**RE: Packer Setting Depth Exception**

Warren Unit Blinebry Tubb WF Well No. 80 (API No. 30-025-26642)  
Unit letter G, Sec 33, T20S, R38E, NMPM  
Injection Permit: R-6906-B (March 15, 1991)

# DOWNHOLE WELL PROFILE REPORT

**Well Name: WARREN UNIT 080W**

EXHIBIT NO. 24-F

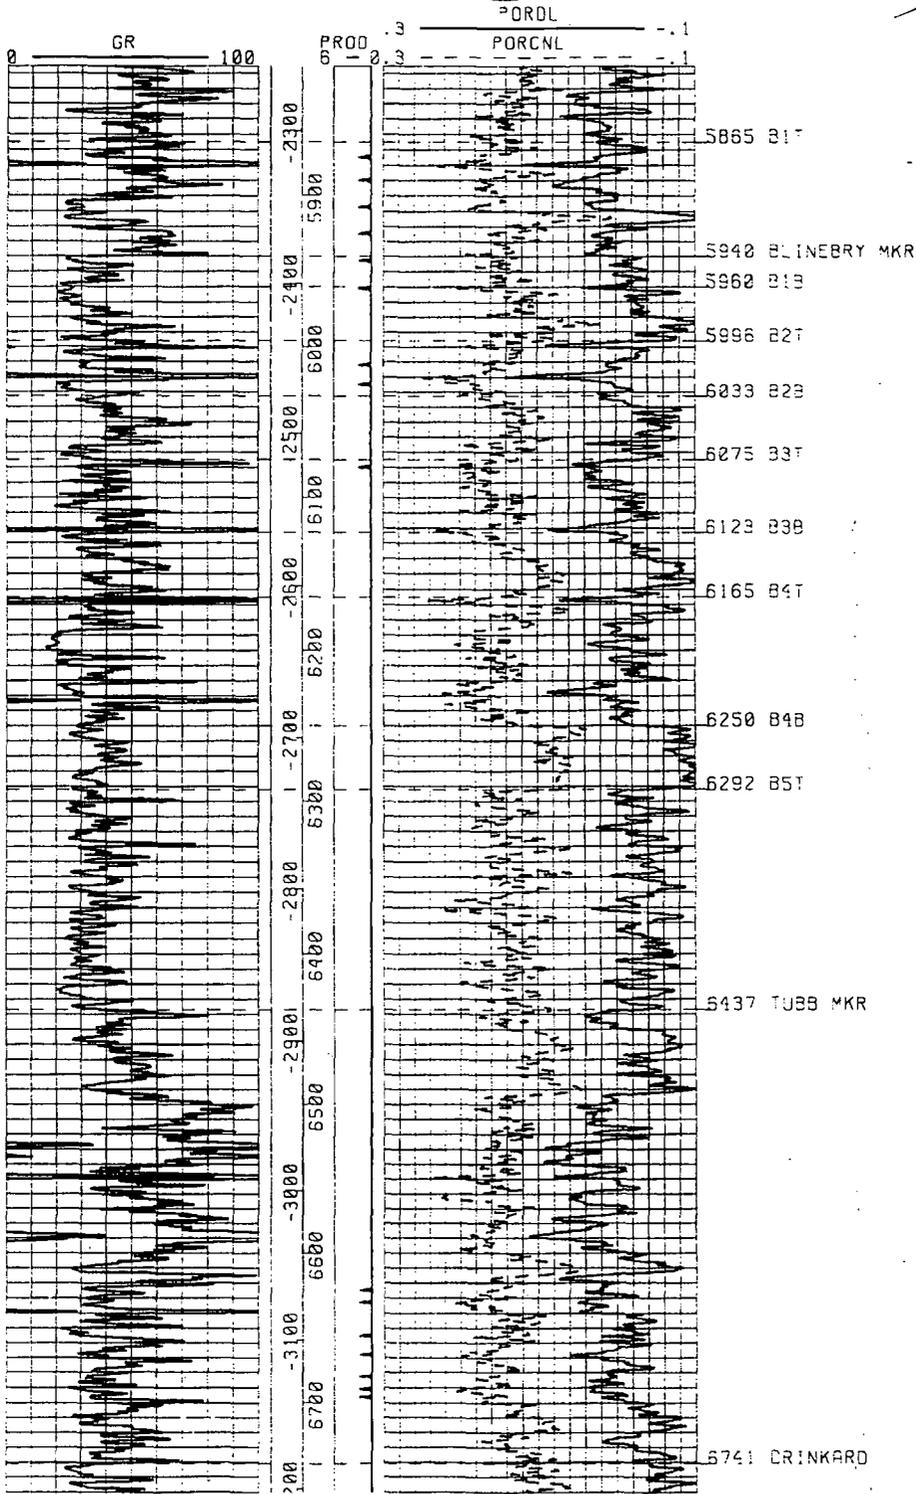
(14) The proposed injection interval would be from the top of the Blinebry (75 feet above the Blinebry marker) down to the base of the Tubb formation (top of the Drinkard). These vertical limits are identified in the Conoco-Warren Unit Well No. 37, located in Unit J, Section 27, Township 20 South, Range 38 East, with the Blinebry top at 5,865 feet and the Tubb base at 6,741 feet. This is an overall interval of 876 feet.

Marker on CG  
5940  
75  
5865
